32-68 Mollison Street, Abbotsford
Urban Design Peer Review

Prepared for the Yarra City Council
October 2019

Figure 1 Incorporated Plan Overlay (C170).

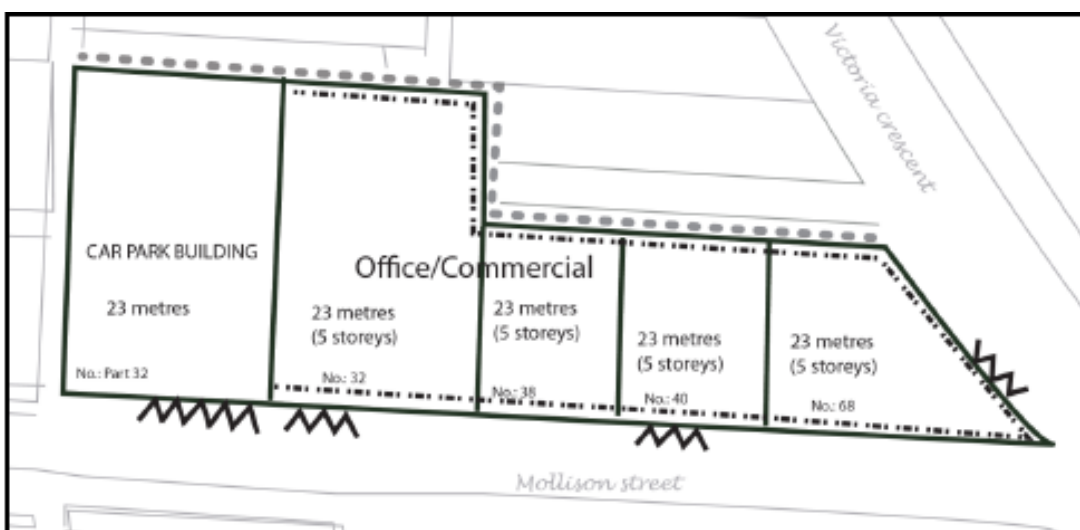
- 3) The purpose of the Incorporated Plan Overlay (see Figure 1) was to facilitate the use and development of the land at 32-68 Mollison Street for office, commercial and other compatible uses.

- 4) The Incorporated Plan Overlay included the following key provisions -
 - » A mandatory maximum height of 23 metres (5 storeys), the management of the northern interface to provide for continued industrial purposes, a building setback above the parapet of 2m, and a preferred vehicle entry/exit identified on Mollison Street and Victoria Crescent.

Figure 3 Approved permit at 12-20 Victoria Crescent (with key factors noted).

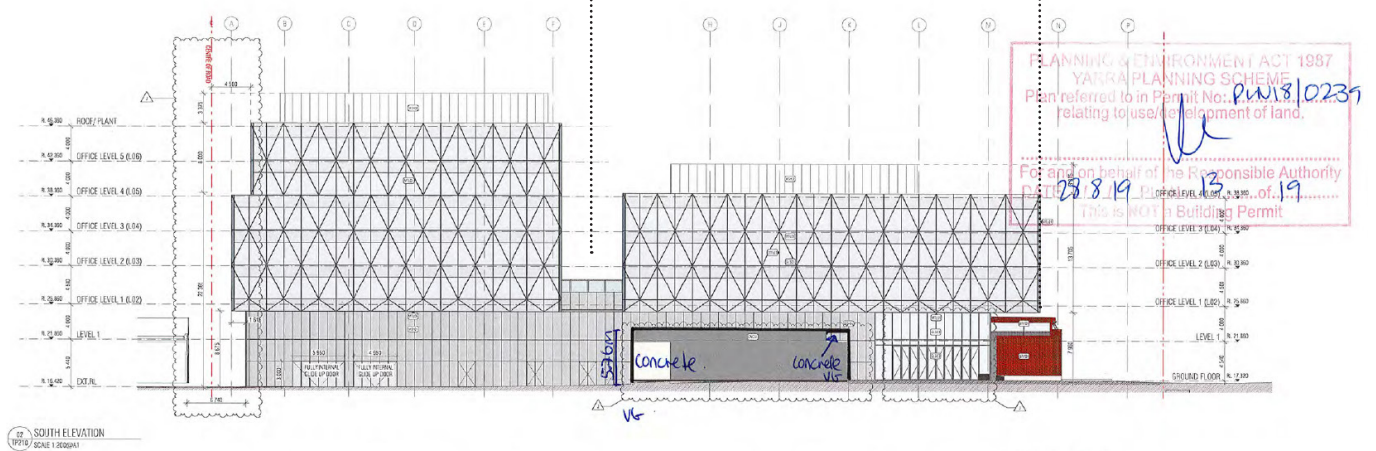
- 50) The subject site is more comparable in size (4,360m²) to the site to the north (approximately 4,100m²).
- 51) The site to the north provides a distinct break in the massing above a two storey podium. The separation between these upper level forms is approximately 7.5 metres (see Figure 3).

- 52) This is unsuccessful in the proposed development on the subject site which provides no distinctive break between the upper level forms for the first five storeys.

- 55) A distinct break should be created in the form of a new pedestrian link (see recommendation on page 8) and upper level setbacks that effectively break the building into three upper level forms.

Figure 6 Looking north-west along William Street towards the subject site.

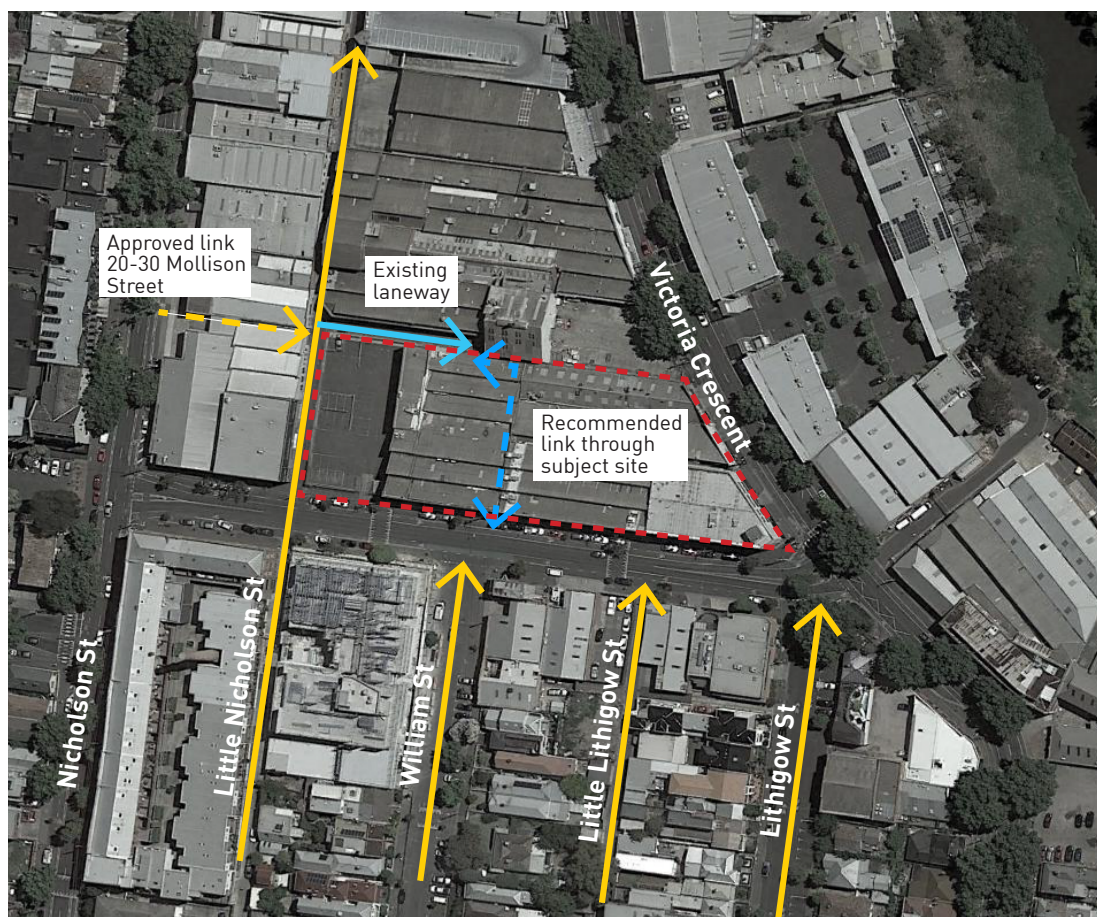
- 27) There is an opportunity to extend William Street to the north which would offer the following benefits within the subject site:
 - » Reducing visual bulk at the Mollison Street frontage by breaking up the overall massing, particularly as its viewed from the low-scale residential dwellings on William Street.

- » Providing an opportunity to reduce traffic impacts on Little Nicholson Street by locating the carpark entrance off a new service laneway.
 - » Improving amenity at the lower levels of the building by increasing outlook.

- » Connecting to the existing laneway to the north of the site and effectively expanding the pedestrian network in line with the proposal at 20-30 Mollison Street in which an east-west pedestrian link has been provided at the northern interface.

- Provide a pedestrian link that connects William Street to the existing laneway to the north of the site (nominally 6m in width).
- Vehicle access to the subject site should occur off a new service laneway within the site.

Figure 11 Proposed development to the west of the subject site [20-30 Mollison St.

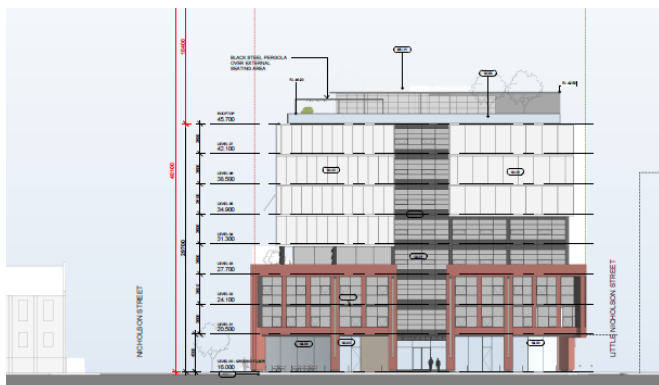
- 33] The recently approved development at 20-30 Mollison Street also provides an indication of emerging street wall heights. This building design establishes a three storey podium in predominantly recycled brick. The podium is reinforced by variable upper level setbacks, a recessed terrace at the fourth storey and a distinct change in materiality above the podium (see Figure 11).

- 34] This is most effective at the Nicholson Street interface where a 4.5 metre setback and a change in materiality creates a clear distinction between the podium and upper levels.
